LTR. W/ATTACHED RE OUR 4/12/76 LTR.....
FURNISHING REQUESTED INFO. RE POTENTIAL
CRACKING IN REACTOR FEEDWATER NOZZLE BLEND
RADII.

Re: Nine Mile Point Unit 1
Docket No. 50-220
DPR-63

Niagara Mohawk Power Corporation
Information Concerning Potential Feedwater Nozzle Cracking
Nine Mile Point Unit 1

FIGURE 1

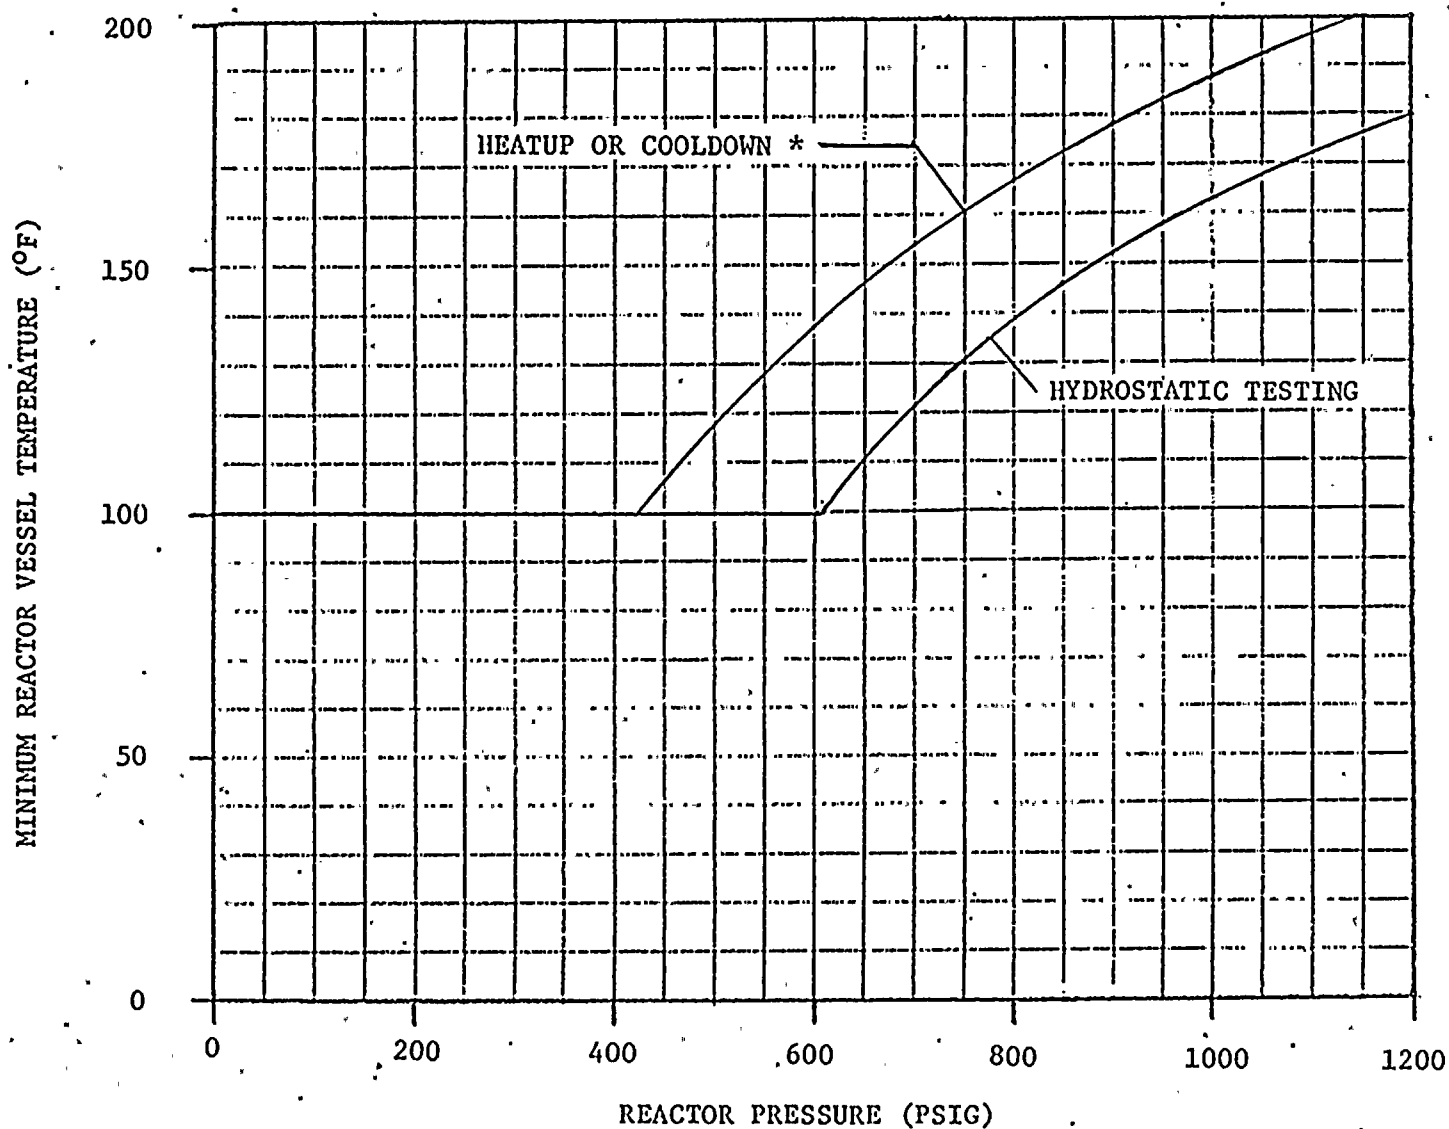
Describe reactor pressure vessel pressure-temperature limits for operating conditions and especially for the inservice-hydrostatic and leak tests.

Reactor pressure vessel minimum temperature limits as a function of reactor internal pressure have been calculated for hydrostatic leak tests and power operation based on postulated feedwater nozzle flaws, as discussed below. Operating procedures are being developed to implement these limits, which are shown in Figure 1.

Minimum pressurization temperatures were calculated using the criteria of Appendix G of Section III of the ASME Boiler and Pressure Vessel Code, (1974 Edition, Winter 1975 Addenda) and the following conservative bases:

1. A postulated flaw size of 2-inches deep was assumed. This value is slightly greater than the $1/4 T$ reference flaw size recommended by the Code and is significantly greater than would be expected based on crack growth analyses and ultrasonic examinations.

2. The A336 nozzle forging material was assumed to have an RT_{NDT} of $+40^{\circ}F$. This value is the maximum value permitted by the vessel procurement specification and is greater than would be expected for this forging material, particularly in the region from the nozzle surface to the $1/4 T$ point -- the location of the postulated flaw.

3. Pressure stresses and stress intensity factor, K , were determined using data presented in Welding Research Council (WRC) Bulletin 175, "PVRC Recommendations on Toughness Requirements for Ferritic Materials." Figure A5-1, for a 2:1 bi-axial stress field. (These data are more conservative than those recommended in WRC 175 for nozzle corner flaws.)

4. In applying the criteria of Appendix G of Section III, it was conservatively assumed that the total peak pressure stress is primary, while in fact, the total pressure stress includes secondary and peak stresses as well as primary stresses.
